29 March 2021

Westfield Penrith DA Access Report

Riley St approach

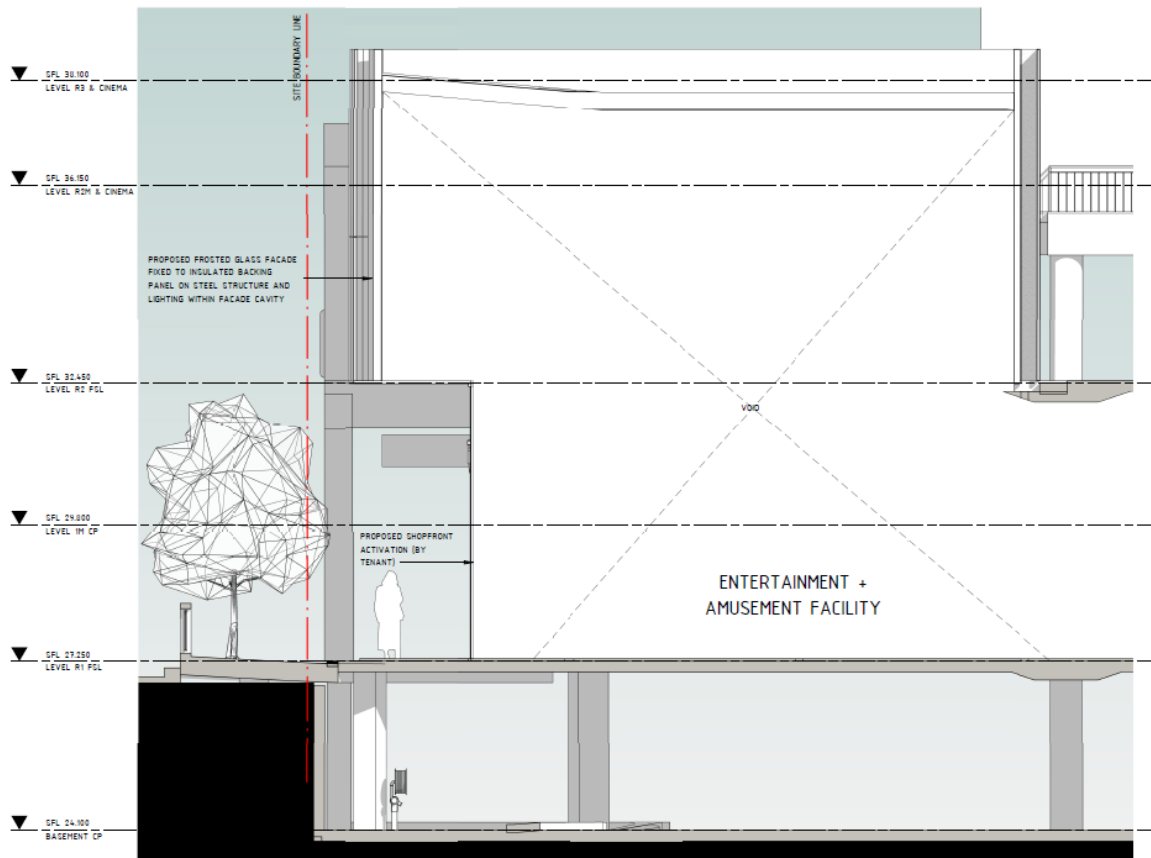
This includes the PDCCP 2014 requirement for complying 2.5m+ wide approach routes. The kerb ramps include minimum 1500 wide footpath landings as attached AS1428.1-2009 extract.

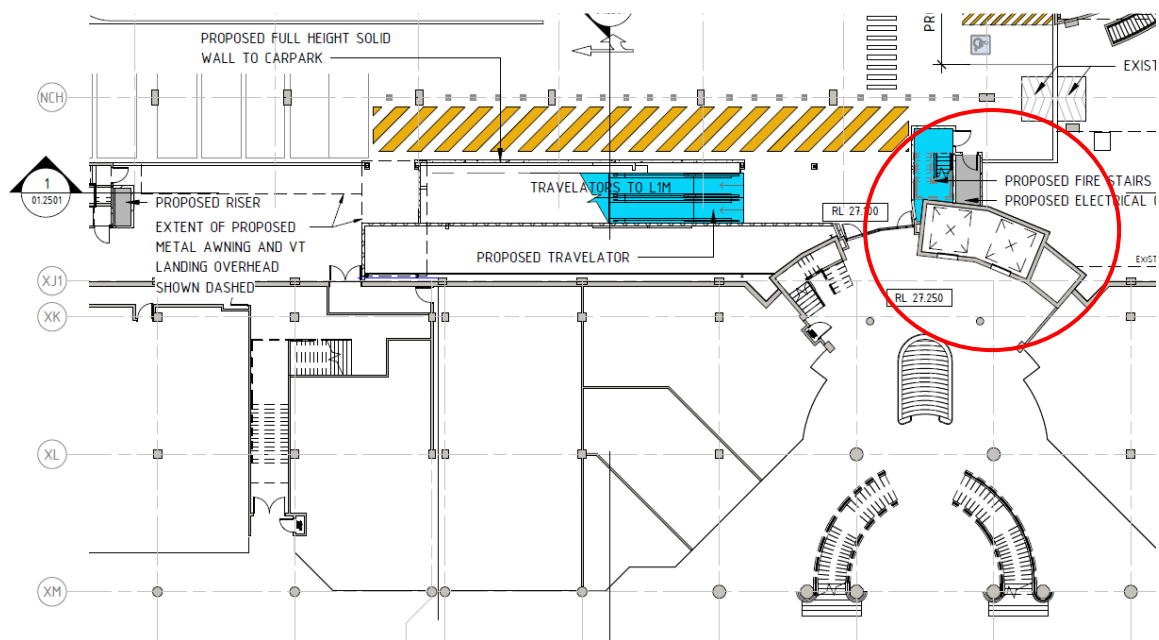
Level 1 proposed works include High St frontage carpark walkways and travelators.

Travelators are not part of an accessible POT, and adjacent lifts are provided together with a new fire stair.

Level 2

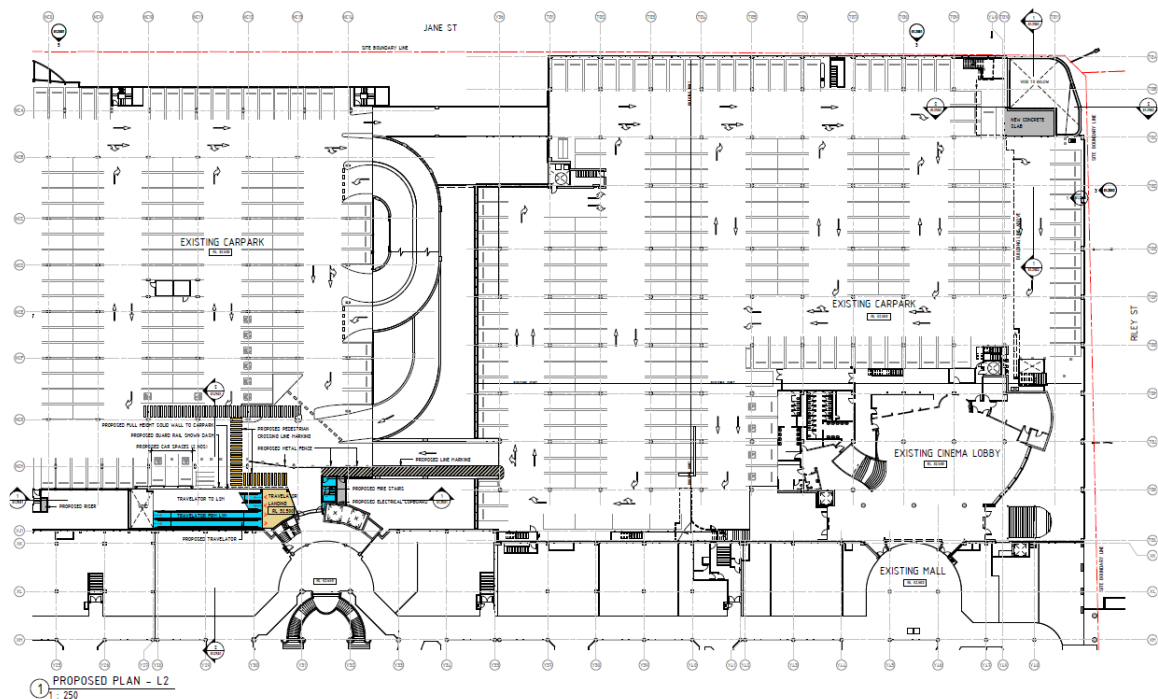
Level 2 proposed works include new roof over the Jane St / Riley St intersection and continuation of High St frontage carpark walkways and travelators.

Travelators are not part of an accessible POT, and adjacent lifts are provided together with a new fire stair.
